[Docket No. FAA-2015-7527; Directorate Identifier 2015-NM-094-AD; Amendment 39-18686; AD 2016-21-05]

**Airworthiness Directives; The Boeing Company Airplanes**

**2016–21–05 The Boeing Company:**  
Amendment 39–18686; Docket No. FAA–2015–7527; Directorate Identifier 2015–NM–094–AD.

**Figure 1 to paragraph (h) of this AD: Wiring Installation - Right Engine Fuel Spar Valve**

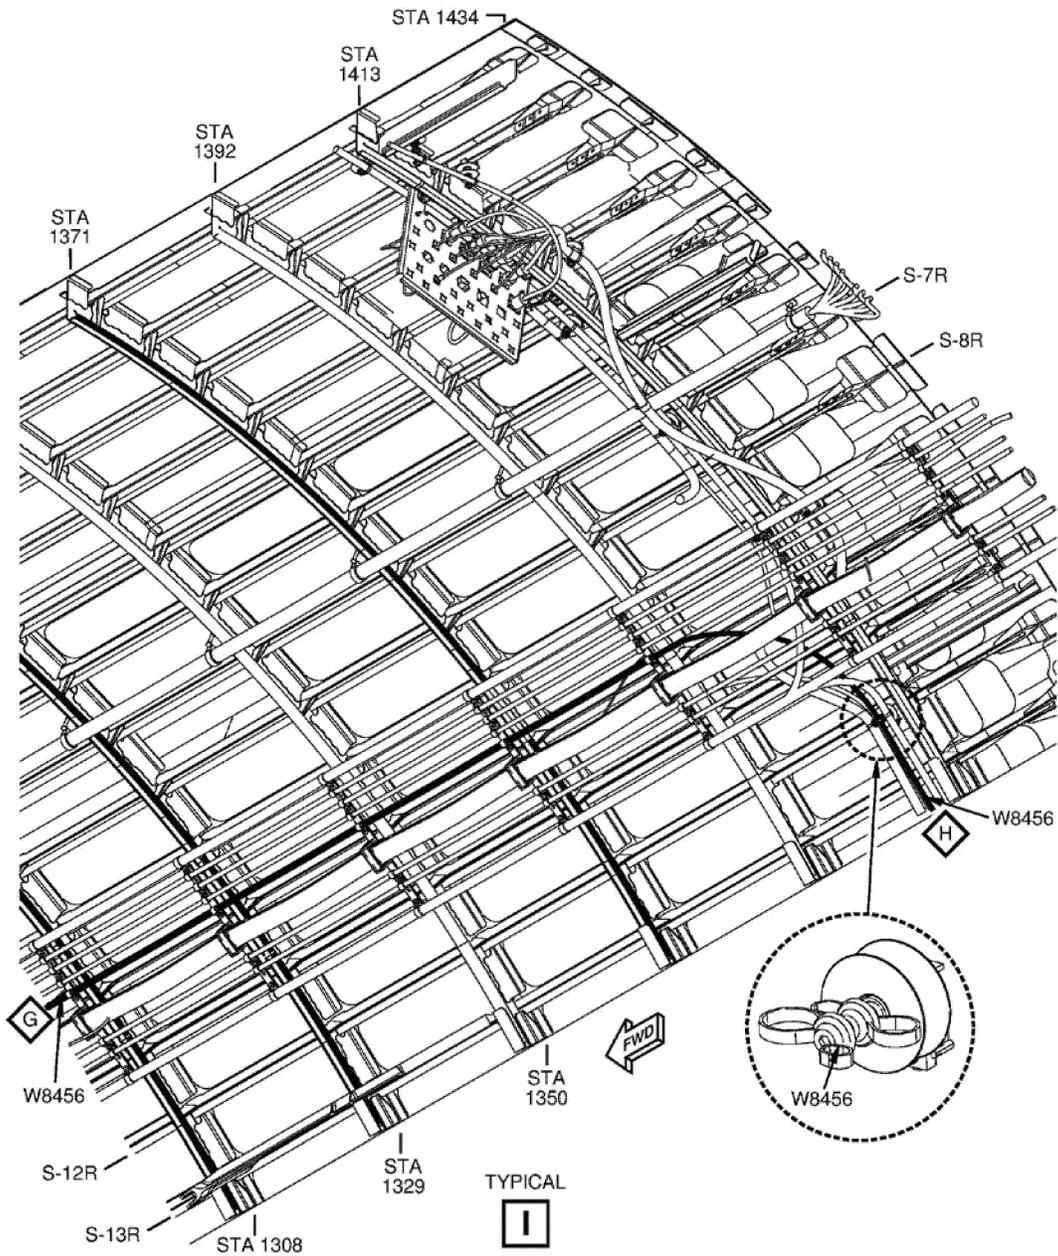
appropriate source of service information in this AD because it is not an FAA-approved document. However, we acknowledge that for certain airplanes, Figure 22, Sheet 9, of Boeing Special Attention Service Bulletin 777-28-0061, Revision 2, dated May 4, 2015, includes an editorial error, which shows incorrect wire routing. Boeing Service Bulletin Information Notice 777-28-0061, IN 03, dated November 16, 2015, allows for a modification of Group 2 airplanes that meets the requirements of the AD without an additional burden to operators. We have included a corrected figure in paragraph (h) of this AD to address this issue.

(1) Where Boeing Special Attention Service Bulletin 777–28–0061, Revision 2, dated May 4, 2015, specifies to use Figure 22, Sheet 9, for the wiring installation of the right engine fuel spar valve, this AD requires using figure 1 to paragraph (h) of this AD.
